HendersonCounty Planning Department Staff Report

Revised Combined Mater and Development Plan Review For The Mountain View Industrial Park Major Subdivision

File #2011-M02 Ray and Katelynn Fussell

Map A: County Comprehensive Plan Future Land Use Map

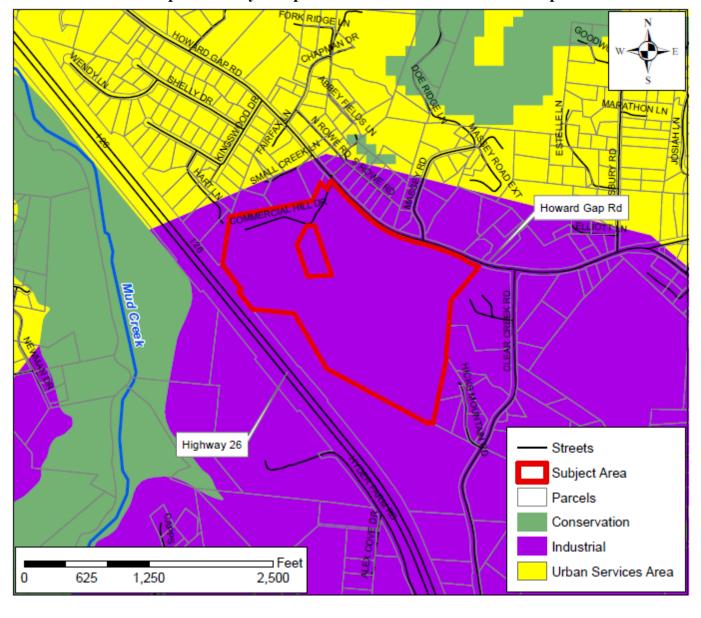
- 1. Henderson County 2020 Comprehensive Plan (CCP). The Future Land Use Map of the CCP shows the project site as being located within the Urban Services Area and Industrial Area (See Map A: CCP Future Land Use Map). The Urban Services Area is that area within which most urban services and urban scale development is currently concentrated. Over the long term, land use regulations and policies should favor higher density development, consistent with natural constraints and the availability of urban services.

- 1.1. **Industrial Area.** The CCP Future Land Use Map identifies the Subject Area as being located in an Industrial Area, a special designation within the urban services area (2020 CCP Pgs. Pgs. 136, 137 & Appendix 1, Map 24). The CCP states, "most defined industrial areas should lie within the Urban Services Area, and in other areas on a very limited basis. Most industrial uses should be segregated from other uses with the exception of Regional Commercial uses" (2020 CCP, Pg. 136).
